# **Final Environmental Impact Report (Final EIR)**

## **Los Angeles International Airport (LAX) Northside Plan Update**

## **Responses to Comments and Corrections and Additions to the Draft EIR**

**December 2014**

The DEIR Fails to Identify, and Thus Fails to Analyze Potential Impacts on, Most Existing and Proposed Bikeways in the Vicinity of the Project

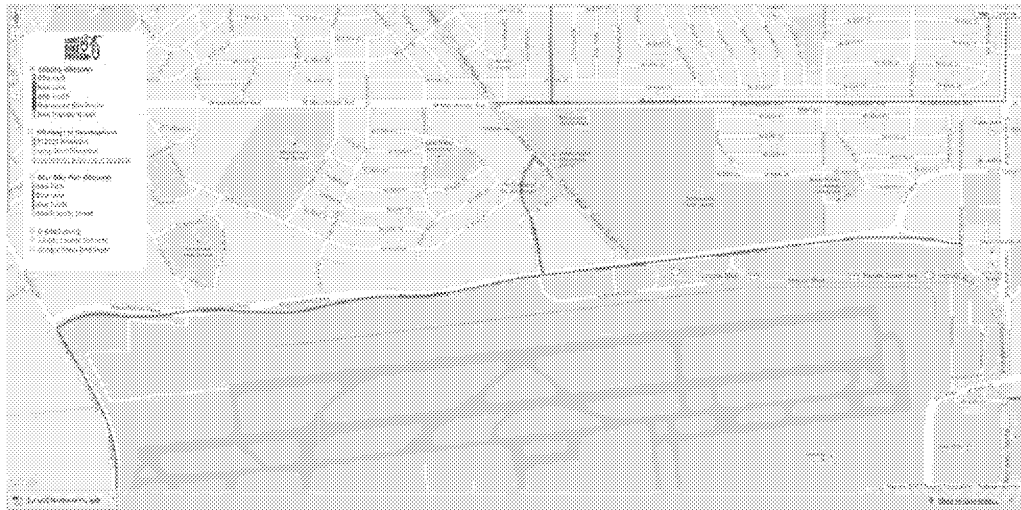
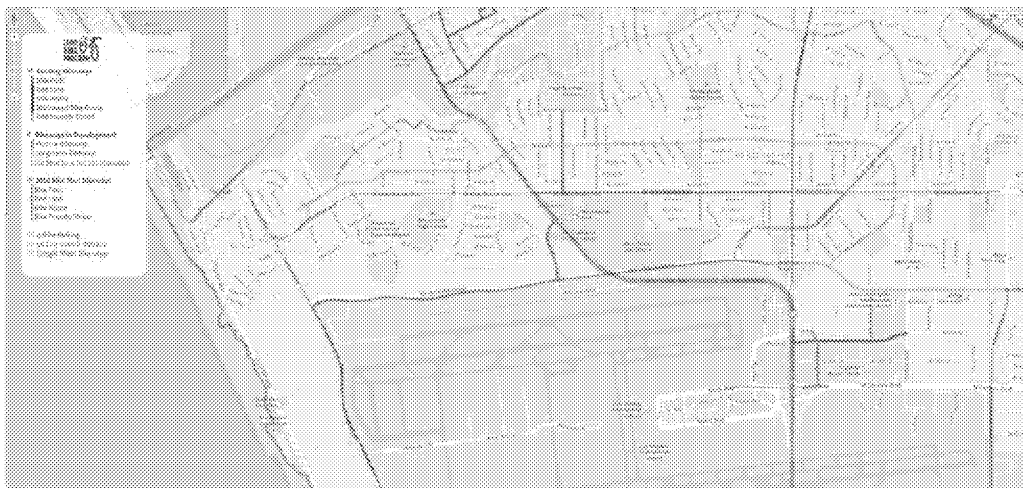
### LAXN-AL05-3 Comment:

The DEIR also states that “bicycle routes are proposed by the *2010 Bicycle Plan* on Loyola Boulevard and Emerson Avenue adjacent to the Project Site.” This description omits most of the 2010 Bike Plan’s proposed bikeways in the vicinity of the project. The map below shows “Bikeways in Development” and “2010 Bike Plan Bikeways” (<http://www.bicyclela.org/fullscreenmap.html>). LADOT is currently developing bikeways on La Tijera Blvd through and to the east of the project, and bikeways on Manchester Avenue east of Sepulveda (just outside the Project Area). In the future, bike lanes are proposed on Pershing Drive north of Manchester, on Lincoln Blvd (PCH), and Sepulveda Boulevard.

None of these proposed bike lane projects are mentioned, and the DEIR thus fails to consider whether the Project will have impacts on these bike facilities. That renders the DEIR legally inadequate.

The comment erroneously states that the Project proposes a construction haul route on Manchester Avenue. As stated on page 4.14-44 of the Draft Environmental Impact Report, three primary haul routes were identified, including Pershing Drive to Imperial Highway to I-105, Sepulveda Boulevard to I-105, and La Tijera Boulevard to I-405. Figure 21 on page 275 of *Transportation Study for the LAX Northside Plan Update* (Gibson Transportation Consulting, Inc., May 2014), provided as Appendix E to the Draft Environmental Impact Report, graphically depicts these haul routes, and doesn't include traffic on Manchester Avenue. The comment states that La Tijera Boulevard has "existing or under development bicycle lanes." There are no existing bicycle lanes on La Tijera Boulevard, and though they are proposed as part of the City's *2010 Bicycle Plan*, they are not designed, scheduled, or funded and therefore it is unknown what effect their eventual implementation may have on La Tijera Boulevard. Regardless, haul truck traffic travels in vehicular travel lanes just like any other vehicle, and has no direct effect on bicycle traffic traveling in dedicated bicycle lanes.

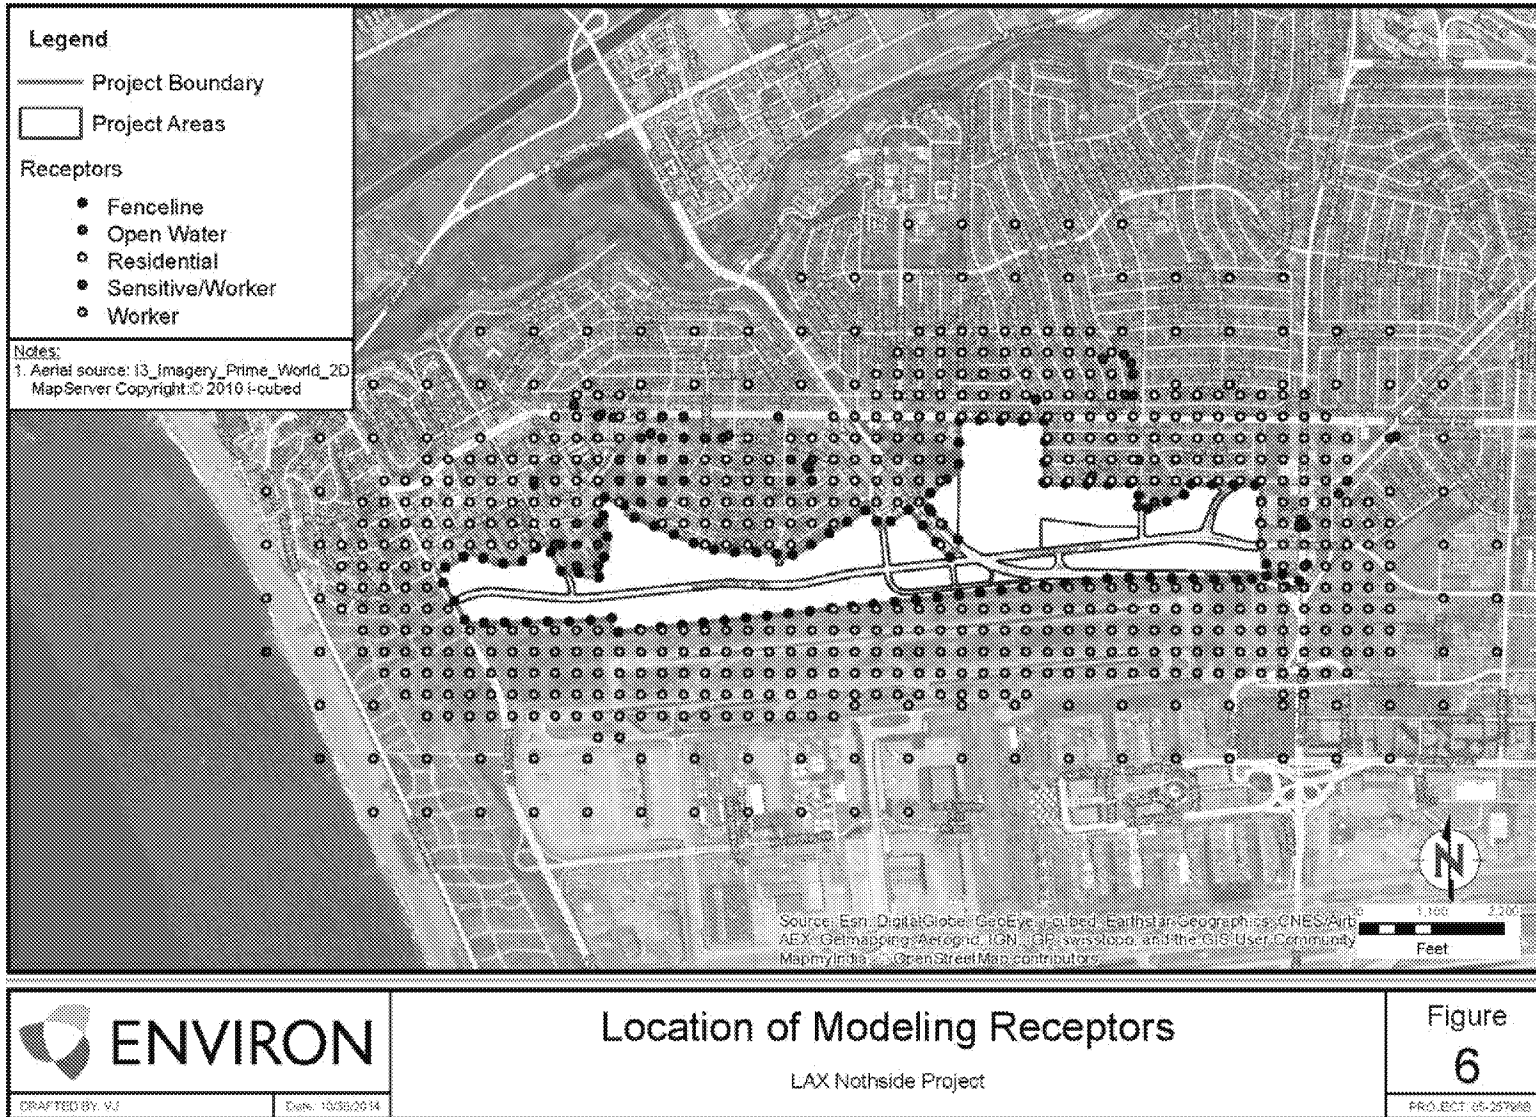
Replace Figure 6 of Appendix C1 Air Quality Technical Report with the following revised figure:

### The DEIR Fails to Identify, and Thus Fails to Analyze Potential Impacts on, Most Existing and Proposed Bikeways in the Vicinity of the Project

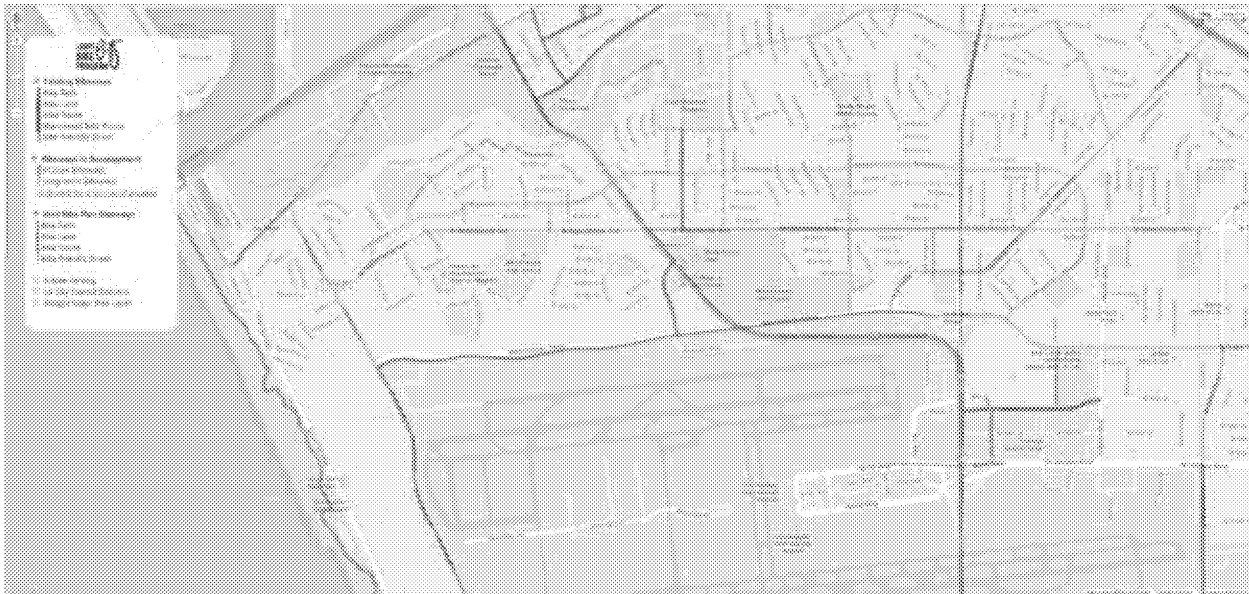
To determine whether the Project conflicts with the 2010 Bike Plan regarding bicycle facilities, the DEIR must first correctly identify the existing and proposed bikeways<sup>1</sup> in applicable plans.<sup>2</sup> Because the DEIR does not do so, its analysis is by definition inadequate. Quite simply, the DEIR cannot evaluate impacts on bikeway projects that it does not acknowledge even exist.

The DEIR ignores most of the existing or potential on-street bikeways in the immediate vicinity of the project. According to the DEIR, “there are currently dedicated bicycle lane on Westchester Parkway and Pershing Drive adjacent to the Project Site.” The map below, from the LADOT Bicycle Program website, <http://www.bicyclela.org>, shows that there are also existing bike lanes on Manchester Avenue and Loyola Drive adjacent to the Project Site.

The DEIR also states that “bicycle routes are proposed by the 2010 Bicycle Plan on Loyola Boulevard and Emerson Avenue adjacent to the Project Site.” This description omits most of the 2010 Bike Plan’s proposed bikeways in the vicinity of the project. The map below shows “Bikeways in Development” and “2010 Bike Plan Bikeways” (<http://www.bicyclela.org/fullscreenmap.html>). LADOT is **currently developing** bikeways on La Tijera Blvd through and to the east of the project, and bikeways on Manchester Avenue east of Sepulveda (just outside the Project Area). In the future, bike lanes are proposed on Pershing Drive north of Manchester, on Lincoln Blvd (PCH), and Sepulveda Boulevard.

None of these proposed bike lane projects are mentioned, and the DEIR thus fails to consider whether the Project will have impacts on these bike facilities. That renders the DEIR legally inadequate.
